**TOWN OF MANCHESTER  
PLANNING AND ZONING COMMISSION**

**RE:** Hari Kuppuraj – 30 Bidwell Street  
PRD Zone Change – Preliminary Site Plan (PRD-0006-2022)

The applicant is requesting approval of a preliminary site development plan and a zone change from Rural Residence to Planned Residential Development (PRD) zone at 30 Bidwell Street.

**OPTIONAL FRONT ELEVATION**

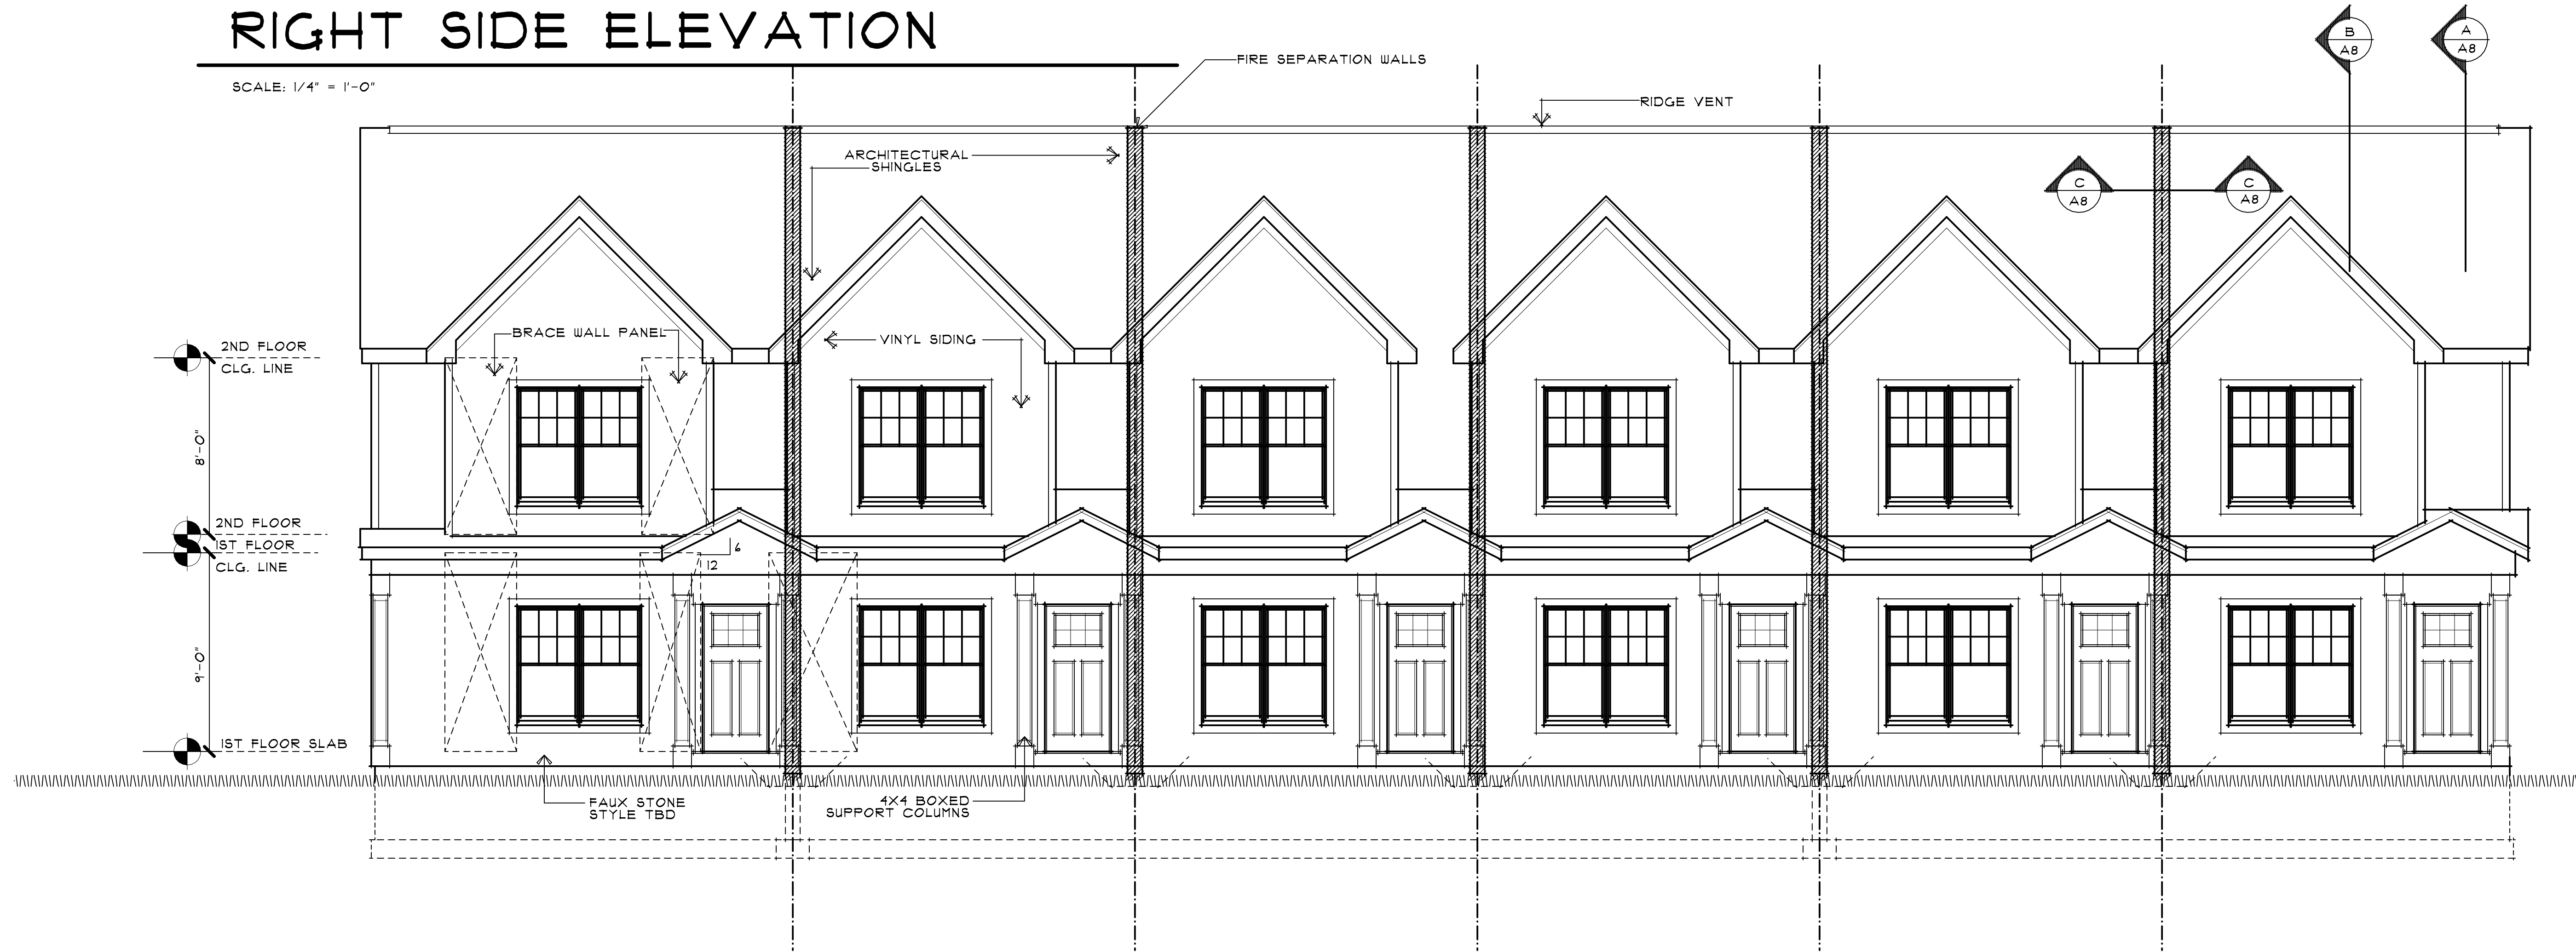
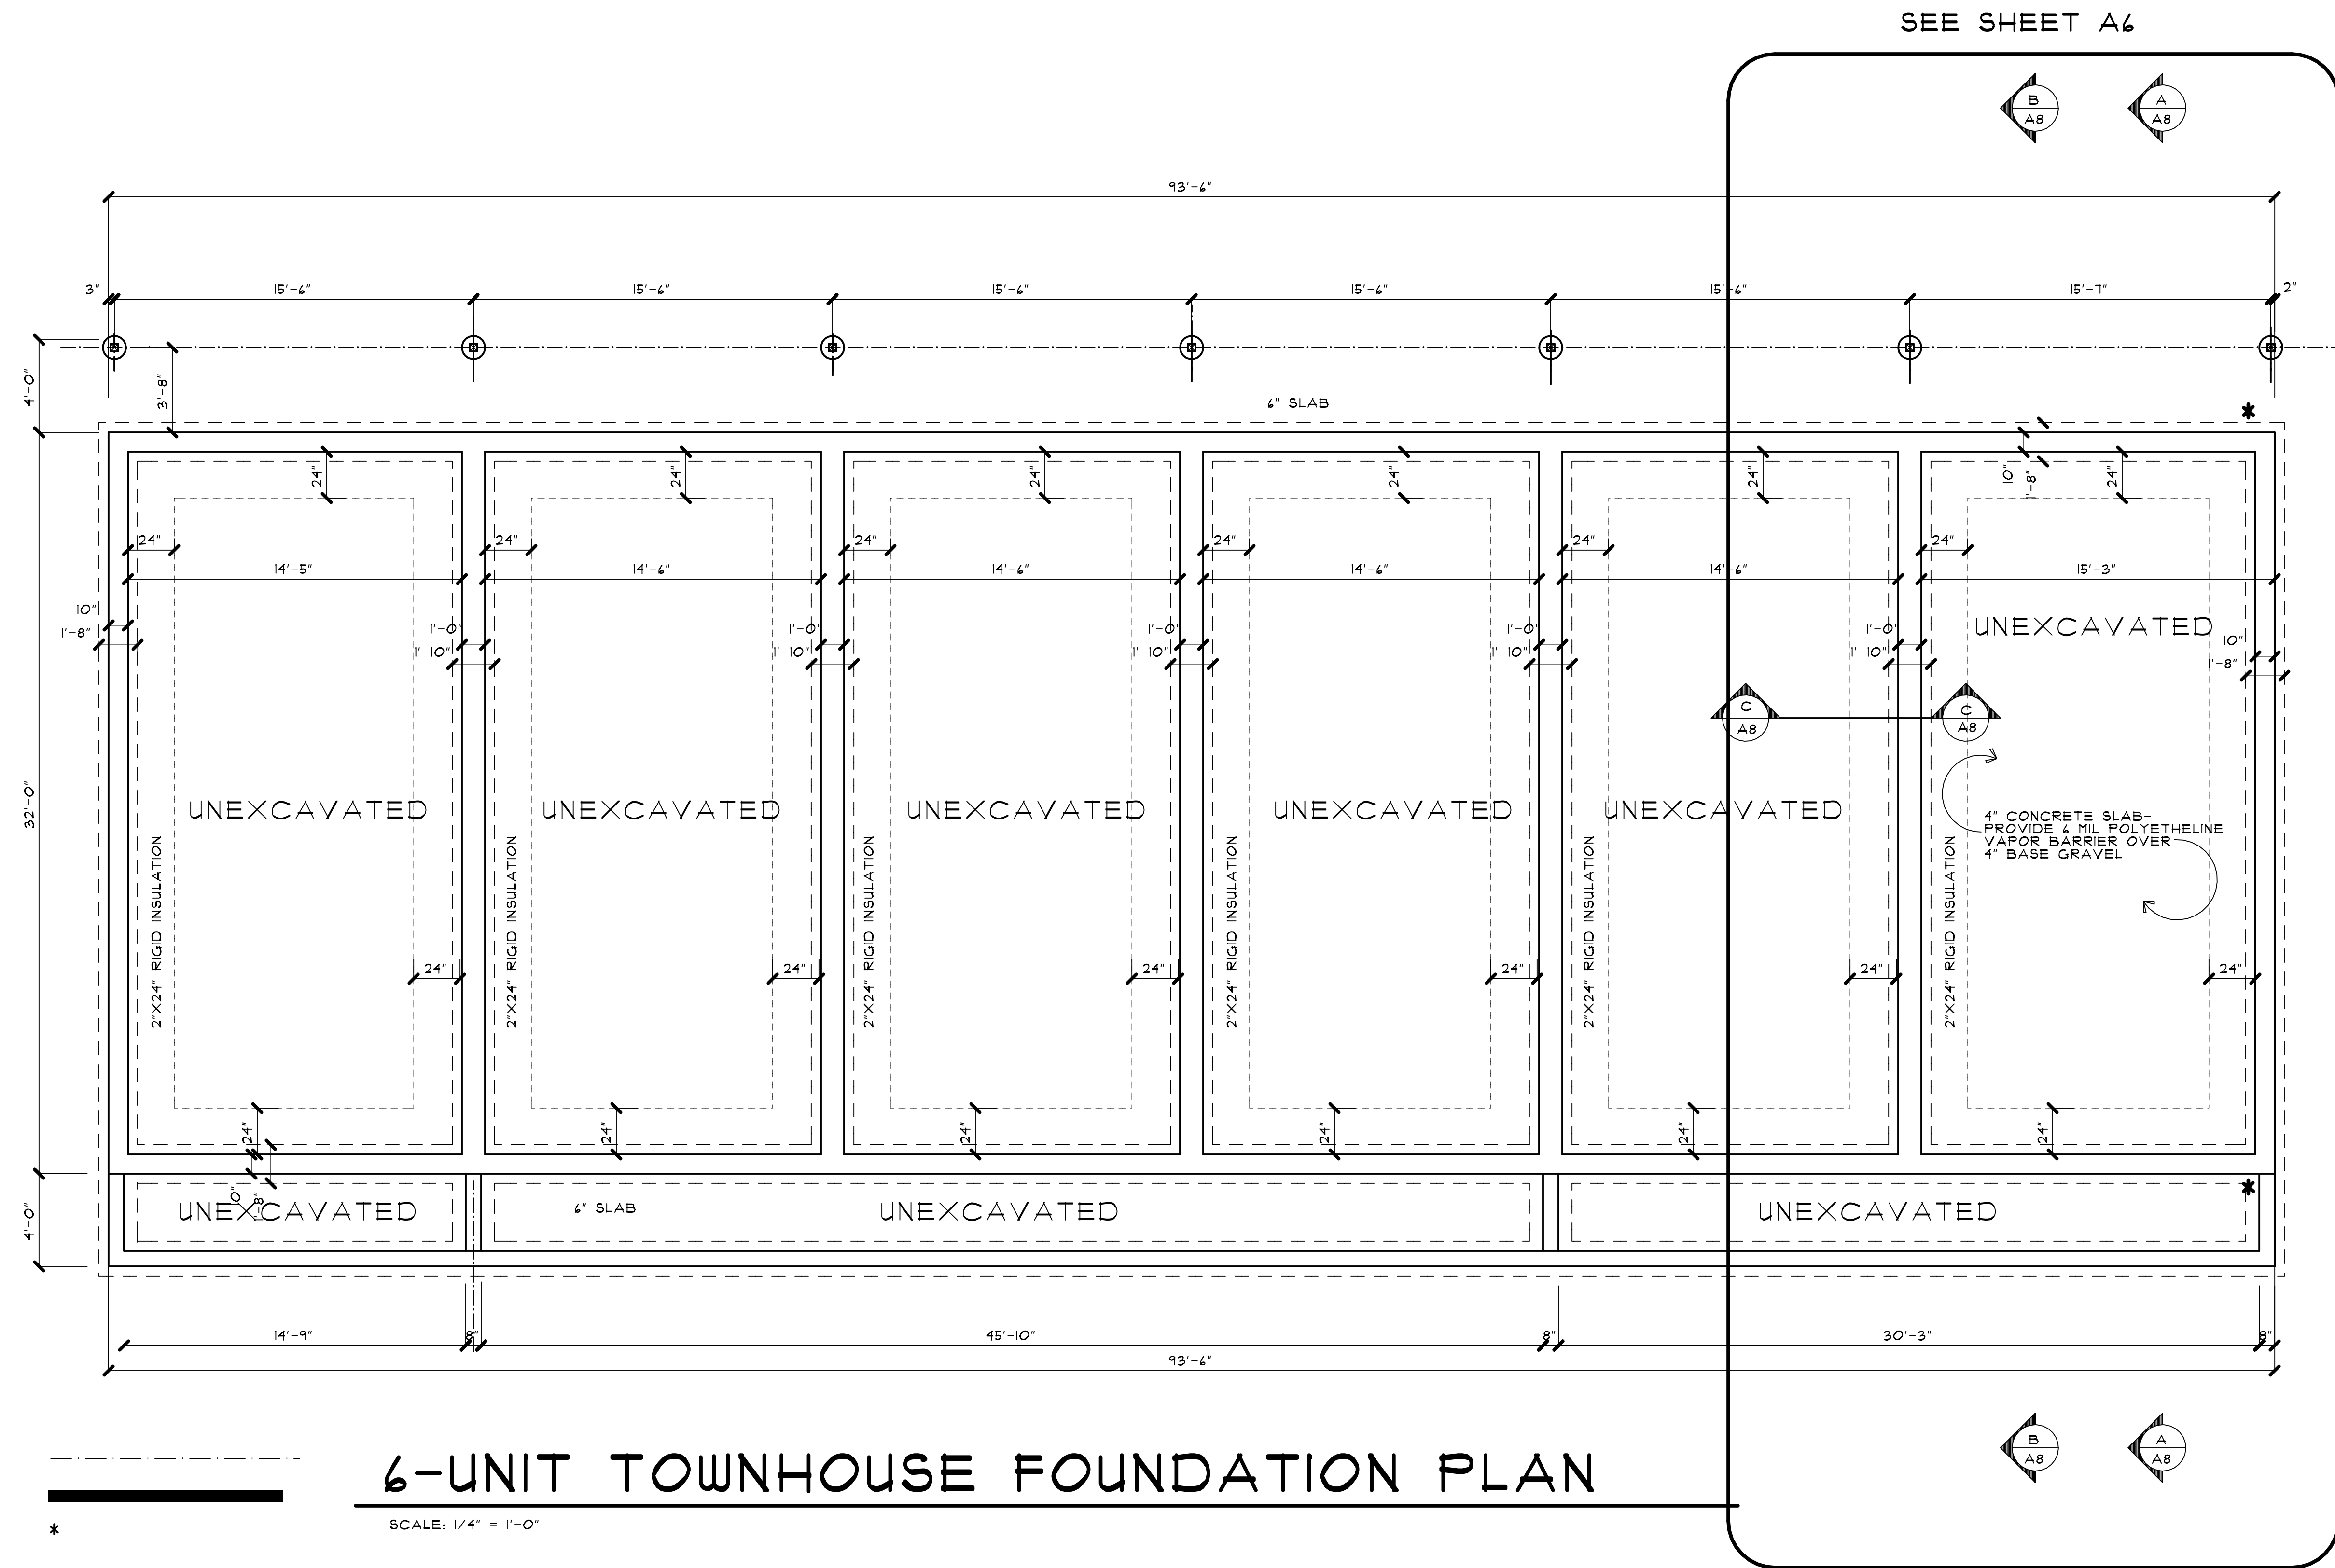
The attached architectural plans show two (2) possible options for the front building elevation, with the main difference being the design of the roof line. In response to staff's request for clarification, the applicant states that this project will use the first option, which shows asymmetrical slanted roofs. The second option (labeled "Optional" on the drawings) is not

intended to be used. Staff request that this option be removed from the final plans if the application is approved.
